N3382A-02A

S E R V I C E N O T E

N3382A PNA Microwave Network Analyzers

Figure 2: A3 Front Panel Interface Board Assy with the Bracket Installed

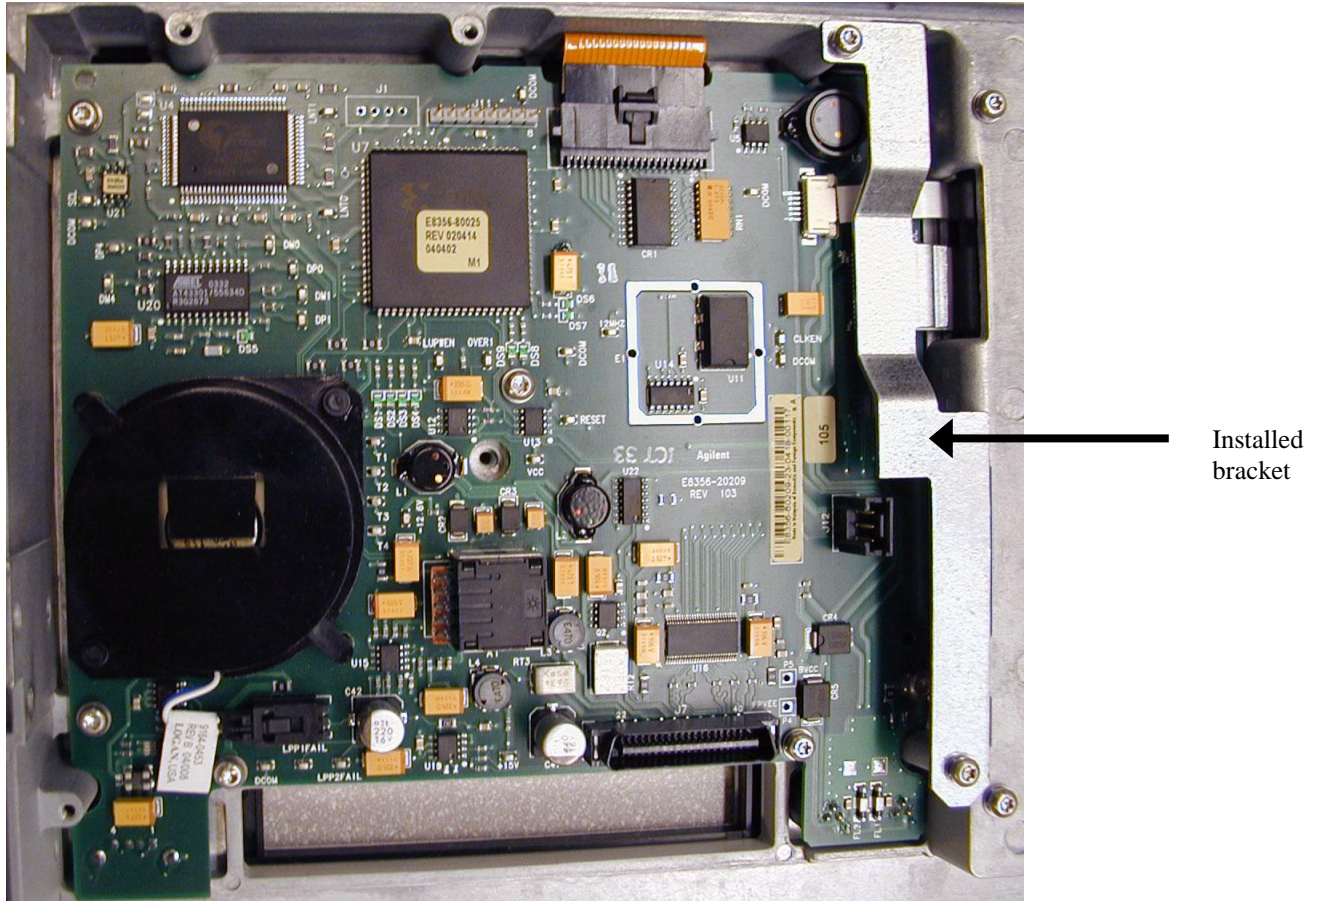
A connector of the ribbon cable (Agilent part number 8120-8409) that joins the front panel display to the front panel interface board can loosen, causing a display failure, unless a new bracket is installed. Because the failure rate has been very low, it is recommended that the bracket be installed only when there is an additional reason to remove the PNA front panel.

1. Refer to Figure 1 in this document:
 - Press down firmly on the ribbon cable's black connector.
 - Locate the two tapped holes for the bracket screws.
2. As shown in Figure 2 in this document, position the bracket so that its holes line-up with the two holes you located in the previous step.
3. Hand-start the two screws, and then torque both to 9 in-lbs.
4. Reinstall the PNA Front Panel by following the Service Guide instructions in the "Replacement Procedure." This is located on the same page as the "Removal Procedure" used previously in step 7.
